ADDENDUM NUMBER 2

MARTIN LUTHER KING COMMUNITY CENTER
HVAC SYSTEM REPLACEMENT
Site #773, Bldg. #2110
1531 West Vliet Street
Milwaukee, WI 53205

Project Number: P202-13610
Notice Number: 6879

Date of Addendum: December 2, 2013

1 PARTIAL LOWER LEVEL POWER PLAN
1/8" = 1'-0"

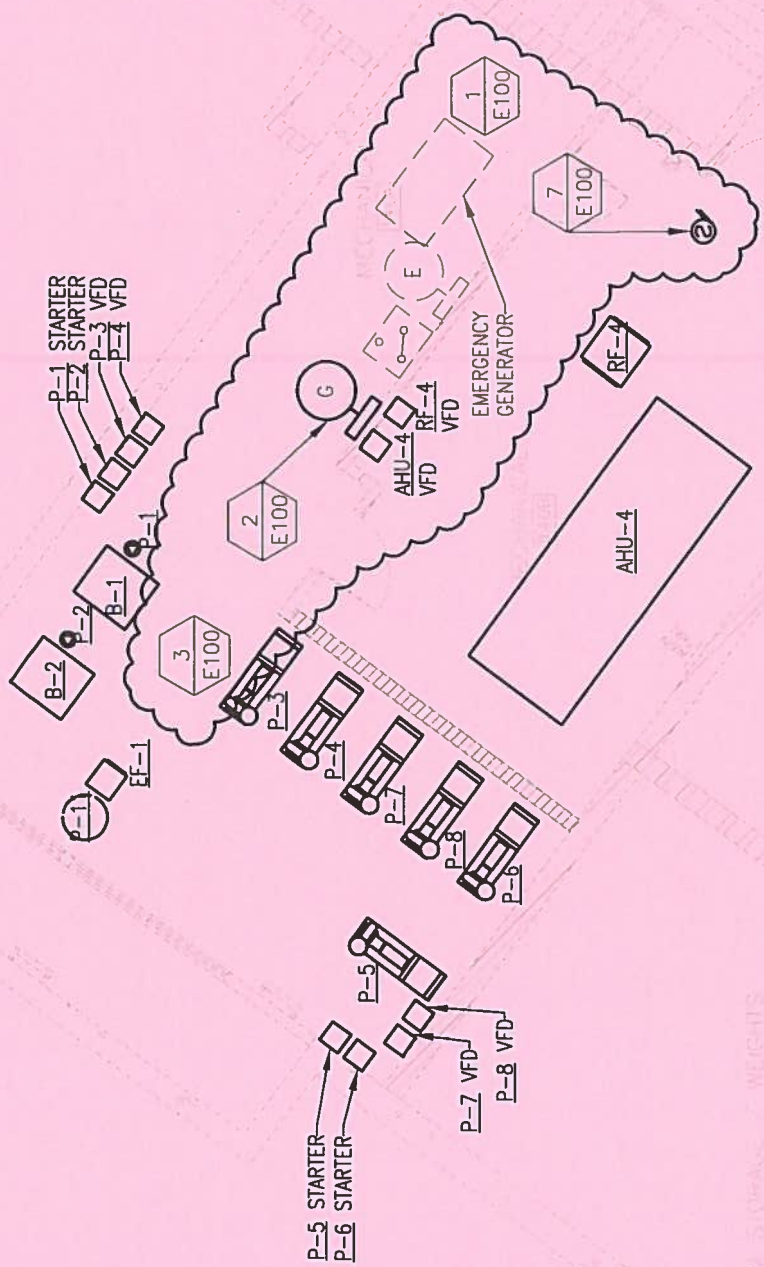
Sheet E100 – Lower Level Power Plan
ADD Panel G and plan notes, see sheet E-1.
ADD Feeder serving ACC-1 on roof and plan notes. See E-2.
ADD Plan Notes, see sheet E-3.
ADD Plan Note 4 to CUH-1, CUH-2 & CUH-3.
ADD Plan Note 6 to Mechanical 147.

1 **PARTIAL LOWER LEVEL POWER PLAN**
1/8" = 1' - 0"

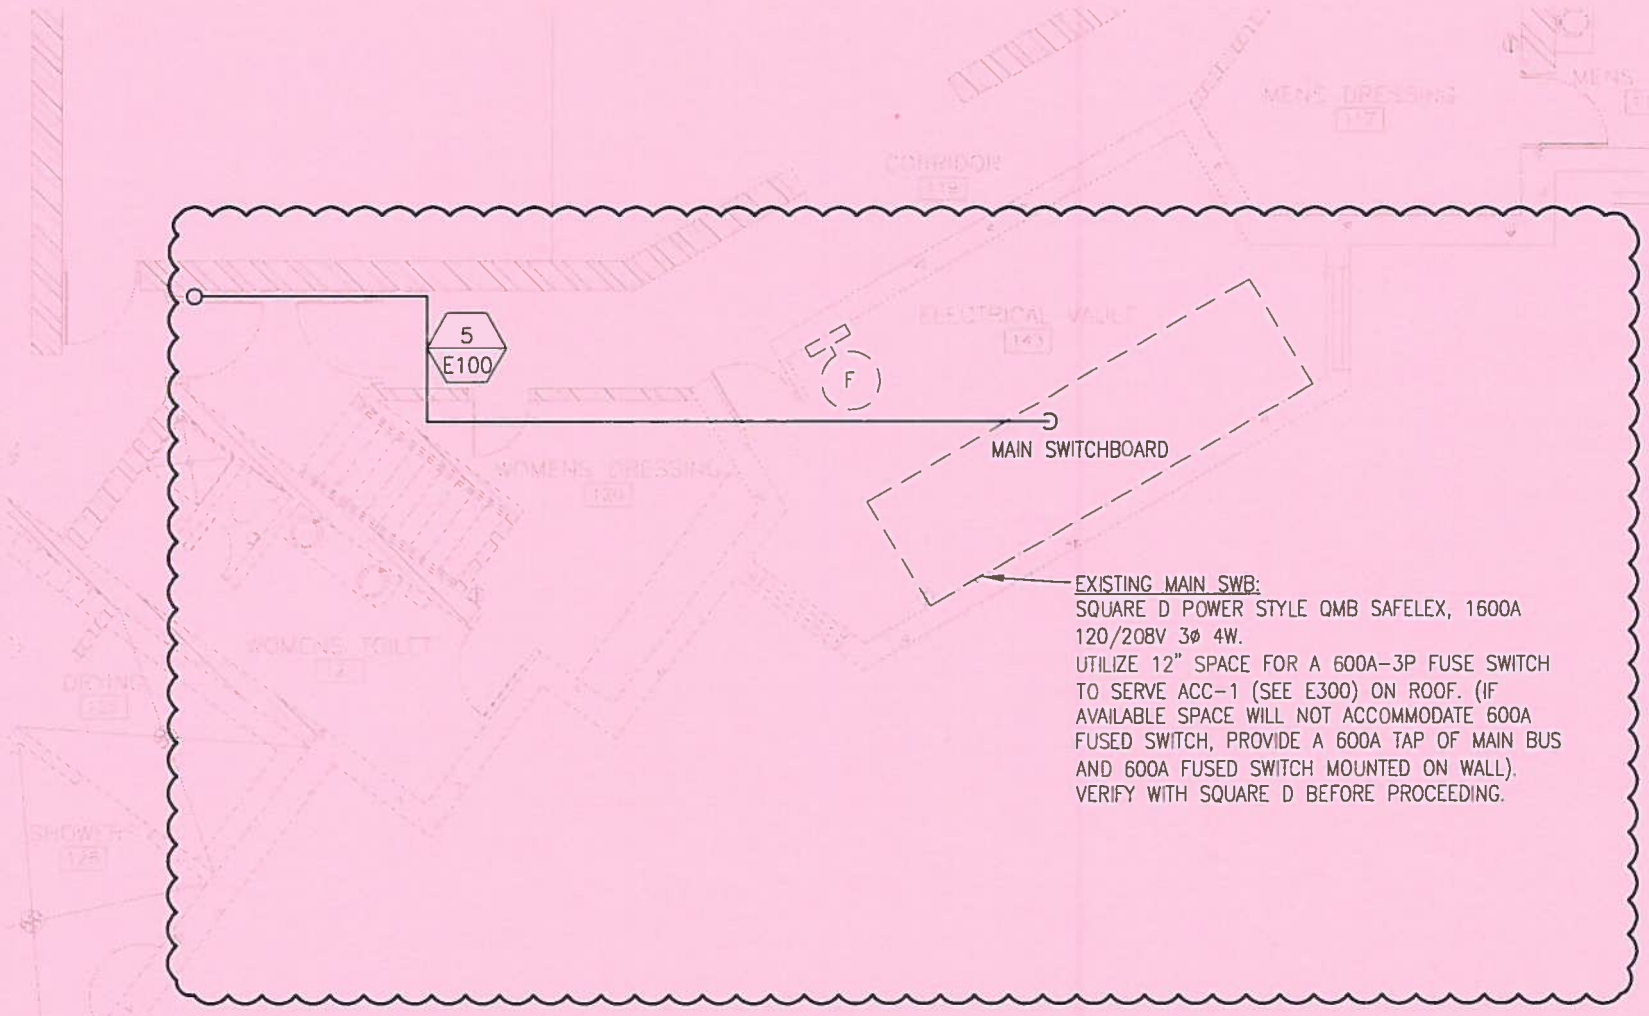
1. -REMOVE EXISTING GENERATOR, TRANSFER SWITCH AND INTERCONNECTING FEEDERS FROM GENERATOR TO TRANSFER SWITCH AND EMERGENCY PANEL.
-DISCONNECT NATURAL GAS PIPING, CITY WATER PIPING (IN & OUT) AND EXHAUST. REMOVE CONCRETE BLOCK BASE. REMOVE EXISTING BATTERIES AND BATTERY CHARGER.
-NEW GENERATOR SHALL BE CITY WATER COOLED, NATURAL GAS, 120/208 3ø BY KOHLER, GENERAC OR EQUAL. TRANSFER SWITCH SHALL BE 40A-3P 208 BY SAME MANUFACTURER AS GENERATOR.
-PROVIDE 6" CONCRETE BASE, FULL LENGTH AND WIDTH OF UNIT. NEW UNIT SHALL INCLUDE GAS PRESSURE REGULATOR, BLOCK HEATER, INSULATED MUFFLER, BATTERIES, BATTERY RACK, AND BATTERY CHARGER.
-SEE MECHANICAL DRAWINGS FOR GAS PIPING AND EXHAUST PIPE INSTALLATION DETAILS. CONFORM TO MANUFACTURER REQUIREMENTS.
-PROVIDE 110V CIRCUIT FROM EXISTING PANEL EM TO SERVE NEW EF-1. PROVIDE 20A C/S. UPDATE SCHEDULE.
-EXTEND 4#6-1 1/4"C #10G FROM EXISTING EM PANEL TO ATS THEN TO GEN SET. EXTEND START CIRCUIT (3#10) FROM ATS TO GEN SET.

2. NEW PANEL G: SQUARE D NQOB WITH BOLTED CIRCUIT BREAKERS. 200A 3ø 4W BUS. 4-60A-3P, 2-20A-3P, 2-30A-3P, 6-20A-1P, 12 SPACES. TAP EXISTING FEEDER SERVING EXISTING PANEL. PROVIDE 200A FUSED SWITCH. EXTEND 4-3/0 #6G 2 1/2" GROUND FROM TAP THRU DISCONNECT SWITCH TO PANEL G.

4. DISCONNECT EXISTING CIRCUIT AT EACH CUH. RECONNECT CIRCUIT TO NEW UNIT. NOTE: THE NEW CUH TERMINATION JUNCTION BOX MAY BE ON OPPOSITE END OF EXISTING UNITS. VERIFY IN THE FIELD TO PROPERLY EXTEND CIRCUIT.

6. EXISTING AHU, RF AND PUMP TO BE REMOVED, SEE MECHANICAL DRAWINGS. REMOVE EXISTING AB STARTERS SERVING EXISTING AHU AND EF. REUSE EXISTING 3ø CIRCUITS TO FEED NEW AHU-5, RF-5 AND 120V 1ø P-10 CIRCUIT.

7. WIRE DUCT SMOKE DETECTOR TO EXISTING SIMPLEX 4010 FIRE ALARM SYSTEM. CONSULT WITH SIMPLEX TO INTEGRATE FUNCTION. SEE SMOKE DUCT DETAIL. SEE MECHANICAL SEQUENCE OF OPERATIONS SPECIFICATION FOR SHUT DOWN REQUIREMENTS.

1 PARTIAL GROUND FLOOR POWER PLAN
1/8" = 1'-0"

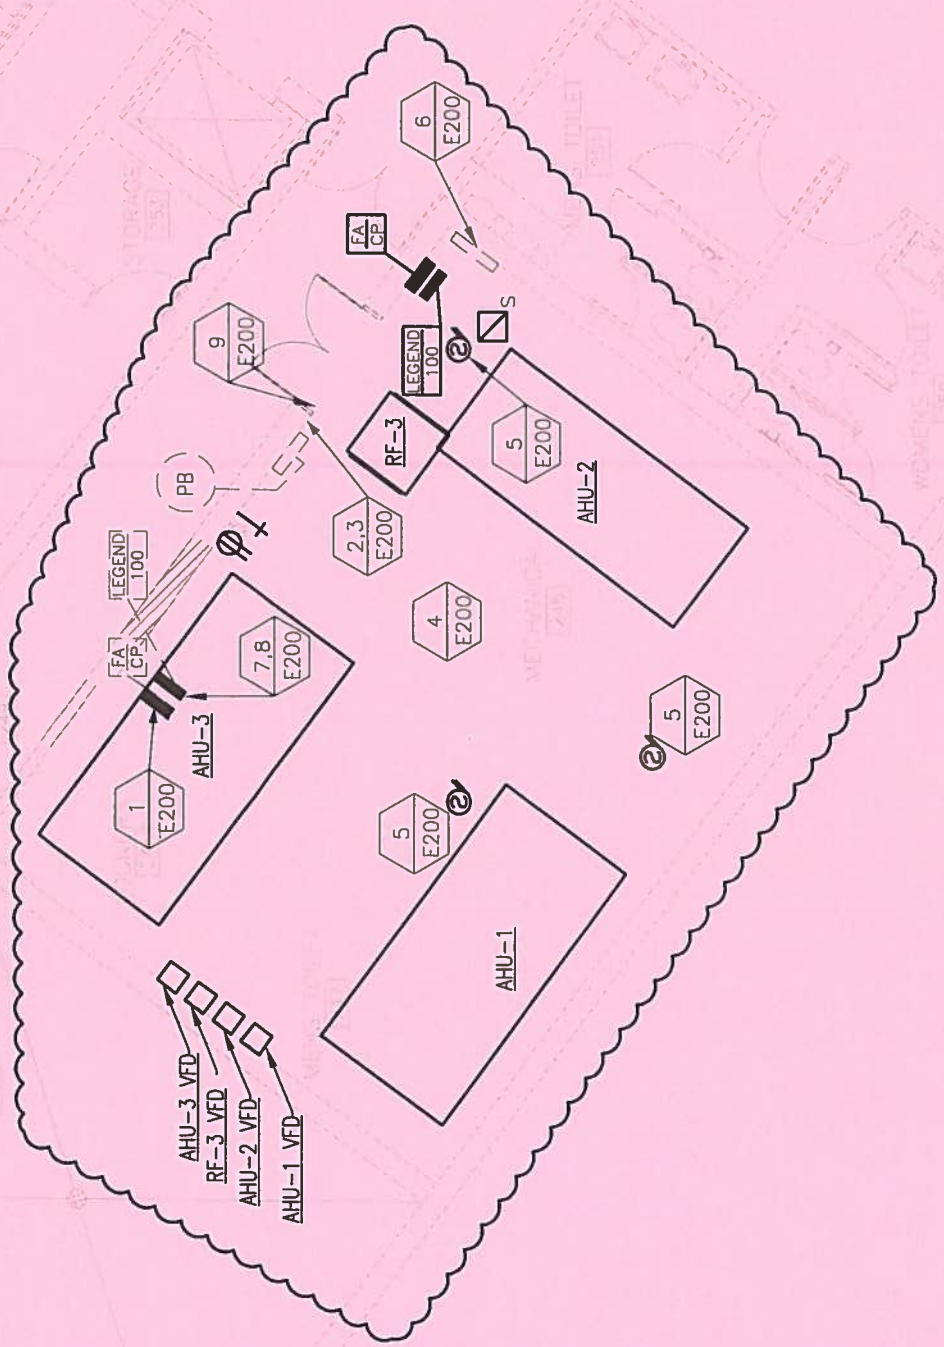
ADD Legend 100 to drawing and plan notes. See sheet E-4.
ADD Plan Notes, see sheet E-5.
ADD Plan Note 10 to CUH-4, CUH-5, CUH-6, CUH-7, CUH-8, CUH-9, CUH-10 & CUH-11.

2. PROVIDE NEW LIGHTING CONTROLS AND RECEPTACLE AT THIS DOOR. EXTEND CIRCUIT AS NEEDED TO LIGHTS AND RECEPTACLE.

4. ADD (3) 2 LAMP STRIP LIGHTS IN SPACE AS DIRECTED IN FIELD. WIRE TO EXISTING SWITCH CIRCUIT.

5. WIRE DUCT SMOKE DETECTOR TO EXISTING SIMPLEX 4010 FIRE ALARM SYSTEM. CONSULT WITH SIMPLEX TO INTEGRATE FUNCTION. SEE SMOKE DUCT DETAIL. SEE MECHANICAL SEQUENCE OF OPERATIONS SPECIFICATION FOR SHUT DOWN REQUIREMENTS.

6. EXISTING FEEDER IS SERVING PANEL PB. EXISTING FEEDER TO PANEL PB IS IN CONFLICT WITH NEW DOORS OF MECHANICAL ROOM. REROUTE EXISTING 400 AMP FEEDER DN TO FLOOR BELOW, ACROSS CEILING OF BOXING ROOM AND THEN UP TO PANEL PB. SEAL AROUND ALL CORE OPENINGS IN FLOOR. PROVIDE FEEDER TAP DEVICES IN EXISTING JUNCTION BOX. REMOVE EXISTING CONDUIT/FEEDER IN MECHANICAL ROOM.

7. REMOVE EXISTING WIRING TROUGH. REMOVE EXISTING FEEDER AND FEEDER TAPS TO NEW JUNCTION BOX IN CEILING. WIRING TROUGH MUST BE REMOVED FROM WALL. WALL WILL BE DEMOLISHED FROM FLOOR TO CEILING.

8. REMOVE AND RELOCATE EXISTING LEGEND 100 SYSTEM PANEL. SPLICE AND EXTEND ALL CABLES TO NEW PANEL LOCATION ABOVE RELOCATED EXISTING FIRE ALARM CONTROL PANEL. CONSULT WITH SUPPLIER/VENDOR OF SYSTEM TO CONFIRM PROPER PROCEDURE TO IDENTIFY, TAG AND EXTEND ALL LINES. ALL CABLES MUST BE PROPERLY SUPPORTED. CONFIRM WITH SIMPLEX REGARDING CABLES INTERCONNECTING BETWEEN FIRE ALARM CONTROL PANEL AND LEGEND 100. CONSULT WITH OWNER REGARDING LEGEND 100 SYSTEM PRIOR TO INITIATING ANY WORK AND DISTURBANCES TO THE SYSTEM. CONDUCT TEST ON SYSTEM UPON COMPLETION. ENGINEER AND COUNTY SHALL WITNESS TEST.

9. REMOVE (4) EX MS SERVING EF-1, 6, 7, 9. REMOVE (3) EX MAG SERVING S-1, 2, 3. PRV-MAG STARTER SHALL REMAIN.

10. DISCONNECT EXISTING CIRCUIT AT EACH CUH. RECONNECT CIRCUIT TO NEW UNIT. NOTE: THE NEW CUH TERMINATION JUNCTION BOX MAY BE ON OPPOSITE END OF EXISTING UNITS. VERIFY IN THE FIELD TO PROPERLY EXTEND CIRCUIT.

1 **PARTIAL ELECTRICAL ROOF PLAN**
1/8" = 1' - 0"

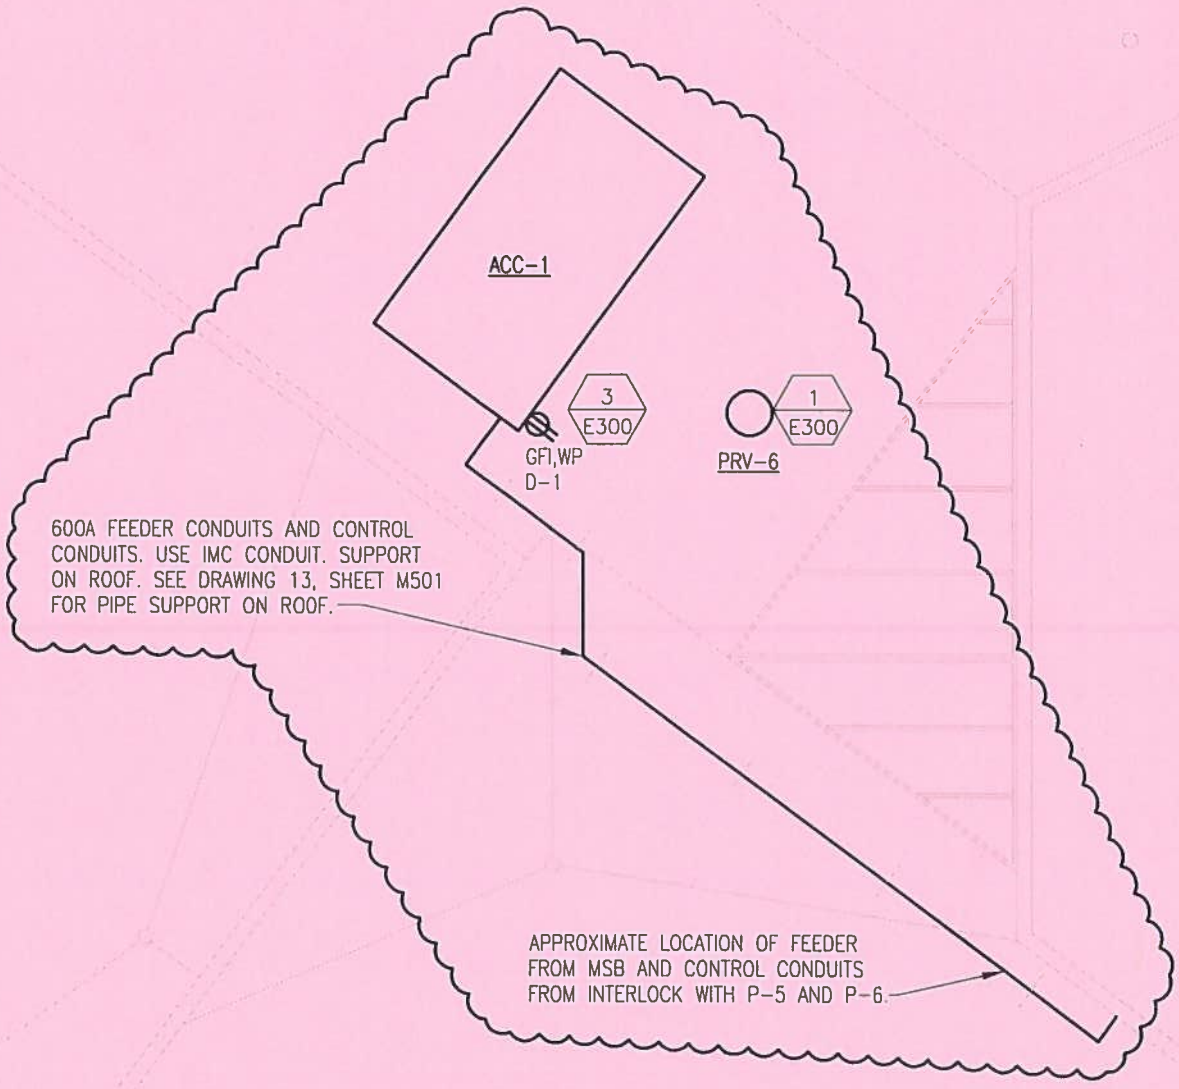
ADD Feeder serving ACC-1, see sheet E-6.
ADD Plan Notes, see sheet E-6.
ADD Plan Notes 1 & 2 to PRV-1, PRV-2, PRV-3, PRV-4, & PRV-5.
ADD Plan Note 1 to PRV-6, see sheet E-6.
ADD Waterproof GFIs located near PRV-1, PRV-2 & PRV-3 shall be circuited to C-1.
ADD Waterproof GFIs located near PRV-4 & PRV-5 shall be circuited to C-2.

1. DISCONNECT EXISTING WIRING TO PRVS. REUSE CIRCUIT WIRING TO SERVE NEW PRVS. REPLACE EXISTING STARTER WITH NEW AS SCHEDULED AT PRESENT LOCATION VERIFIED IN FIELD.

2. EXTEND 110V CIRCUIT TO SEVER WATERPROOF GFI RECEPTACLE FROM NEAREST EXISTING PANEL C OR PANEL D. PROVIDE 20A CIRCUIT BREAKER. UPDATE PANEL SCHEDULE. PROVIDE ROOF PENETRATION AND PROPER SEAL.

3. EXTEND 110V CIRCUIT FROM EXISTING PANEL D. PROVIDE 20A CIRCUIT BREAKER. UPDATE PANEL SCHEDULE.

DUCT SMOKE DETECTOR DETAIL

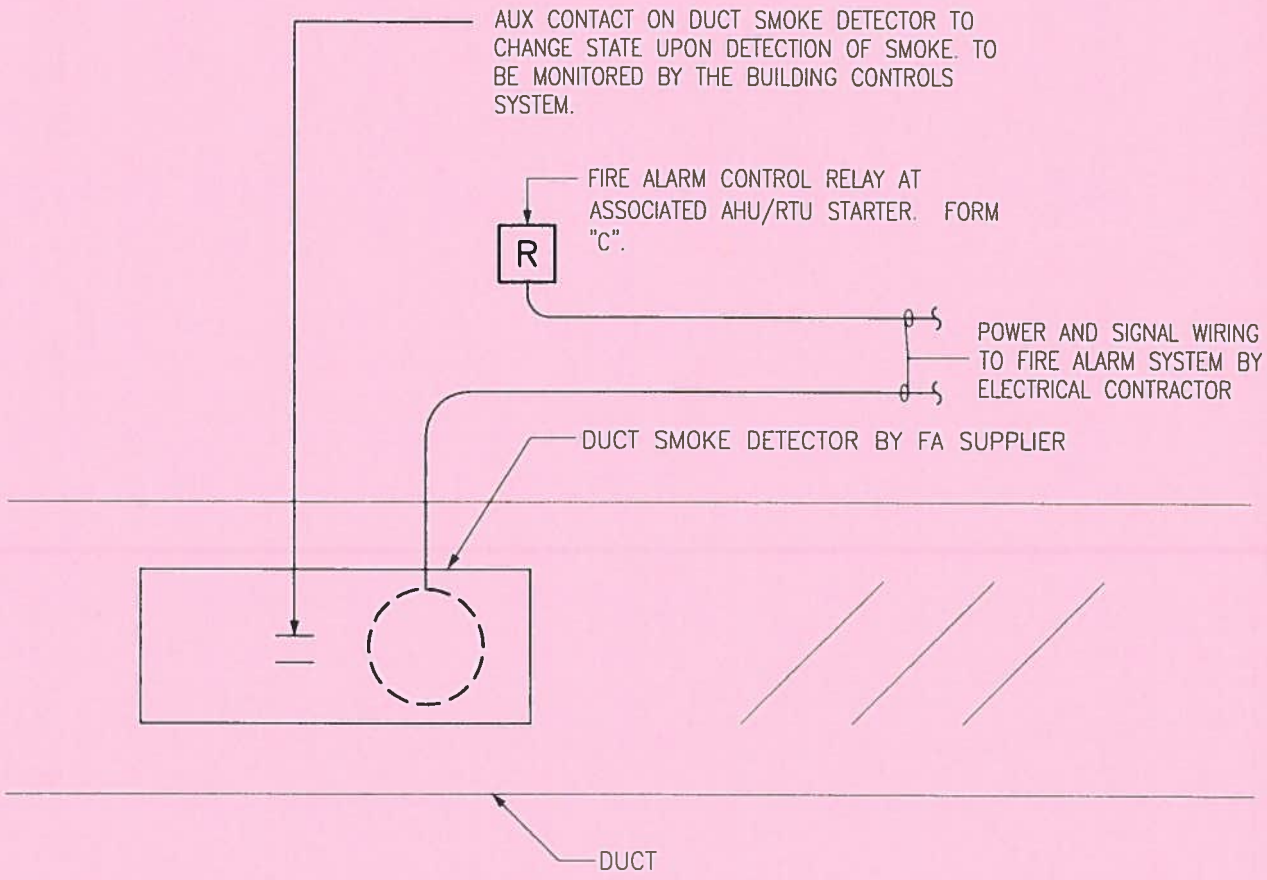
ADD Duct Smoke Detector Detail, see E-7.

1 PARTIAL ROOF FRAMING PLAN

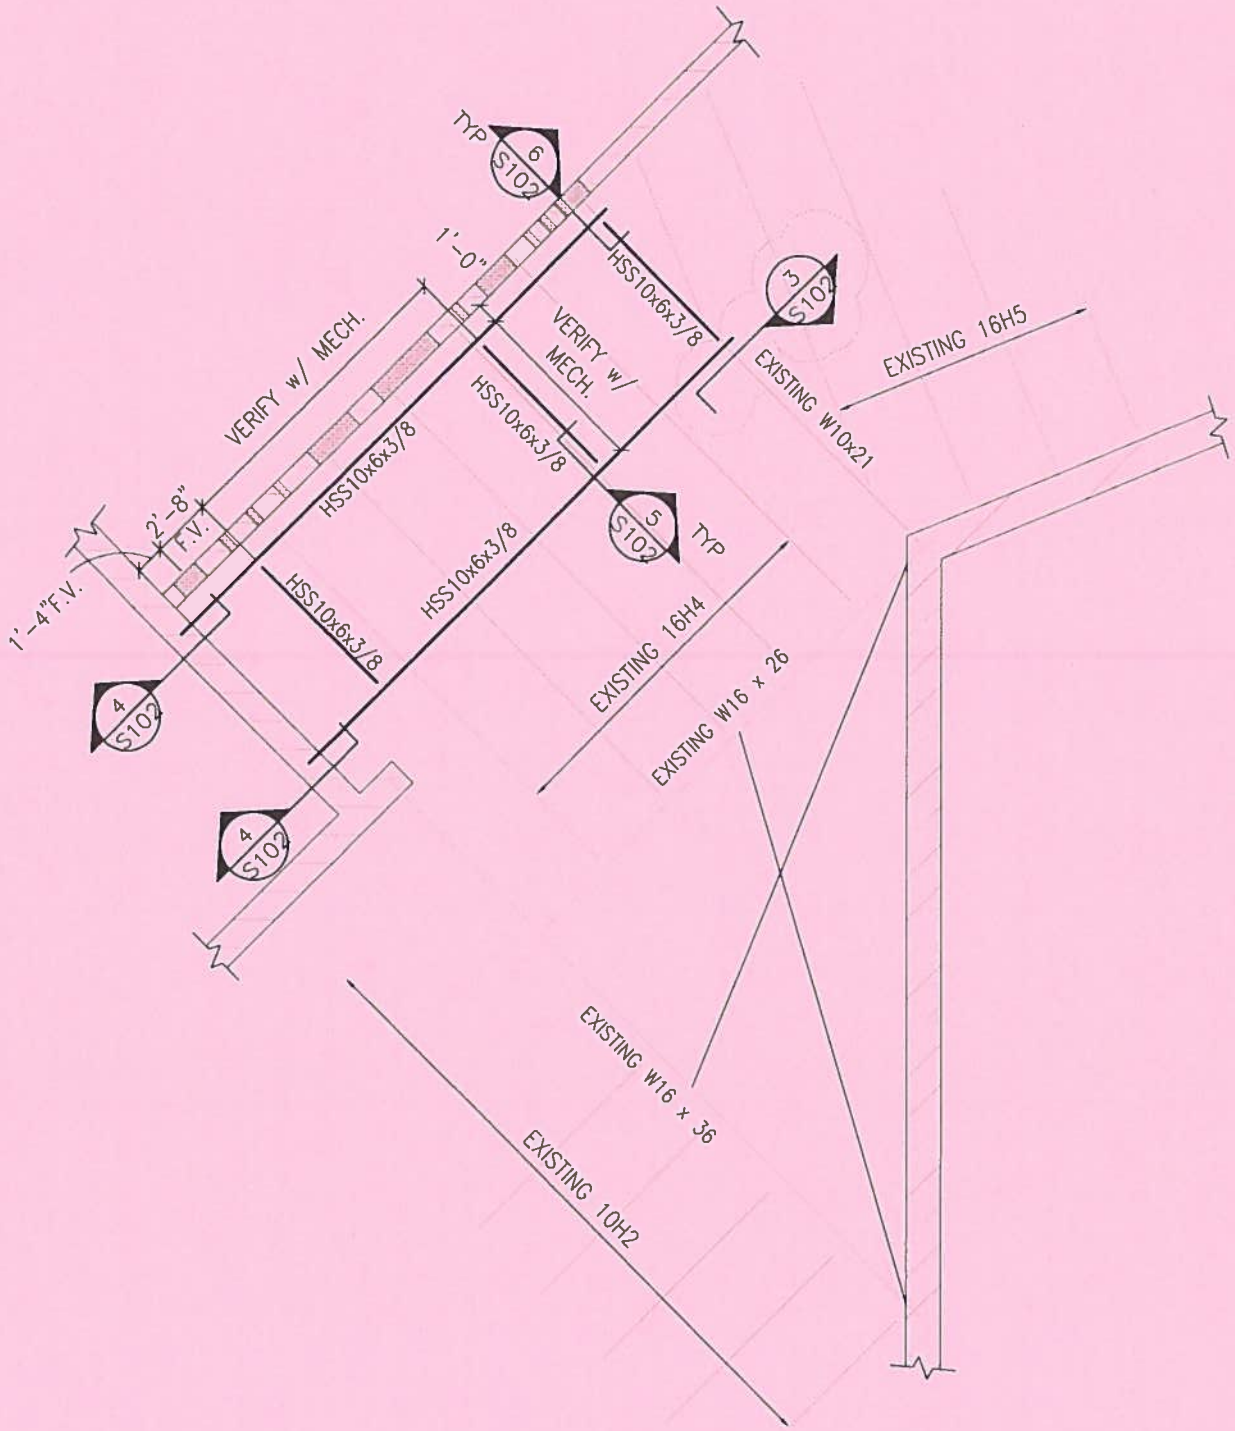
ADD section cut 3/S102 to plan, see S-10.
ADD note to Partial Roof Framing Plan 1/S102, "TOUCH UP ALL WELDS WITH ZINC RICH PAINT.
ADD details 3, see S-11.
ADD angle call out to detail 6/S102, see S-12.
ADD detail 7, see S-13.
REVISE detail 8/S102, see S-14.
